HMT500 A5-R2 / TOP / ACTUAL PCB SILKSCREEN

Reference height 0.80 / 0.60 mm, stroke 0.10 mm | DOTECH wordmark width 8.0 mm (TOP)

Top view

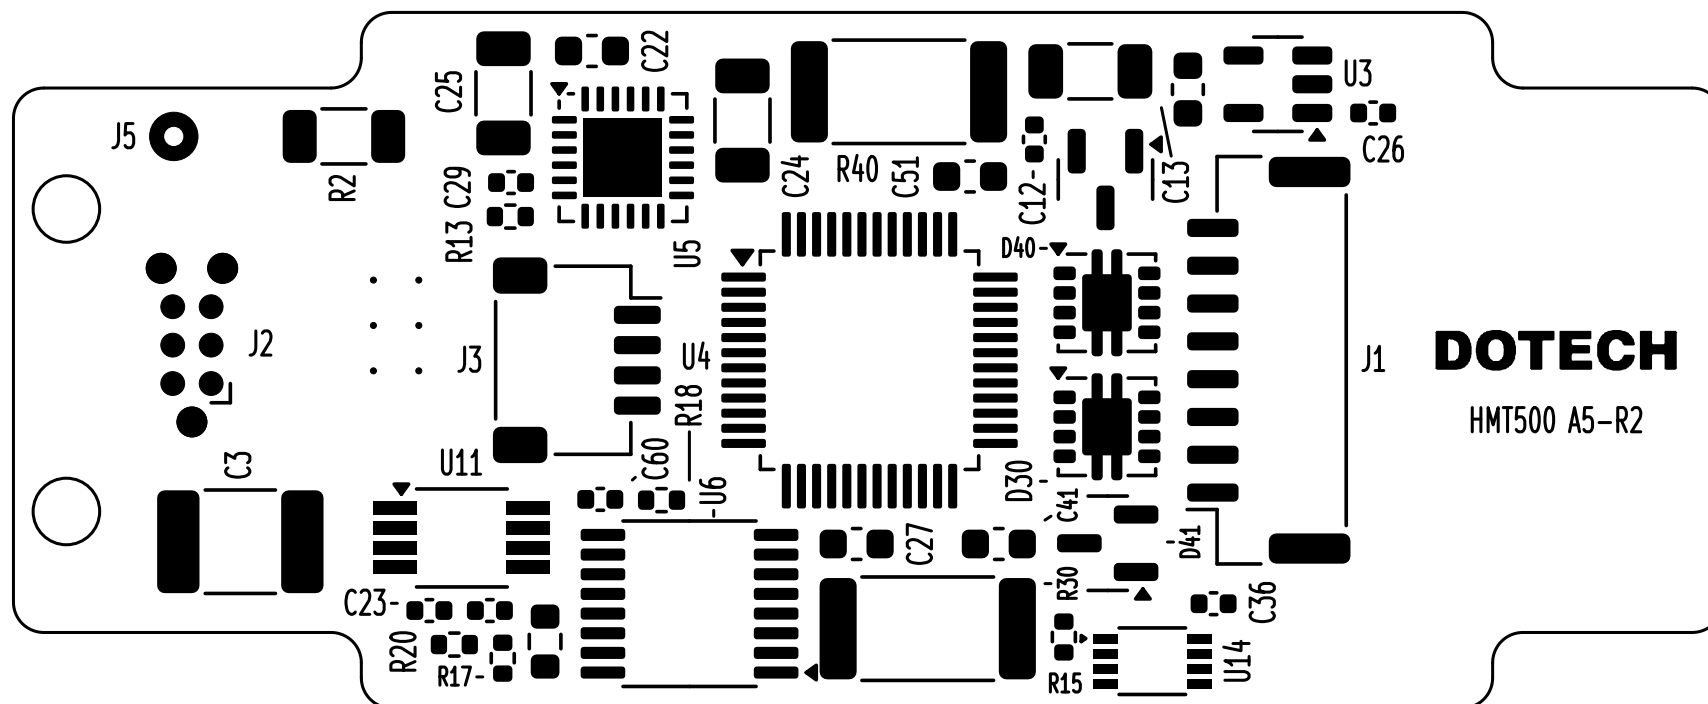
92/110 refs printed; 18 omitted; 22 refs at 0.60 mm require fabrication legibility confirmation.
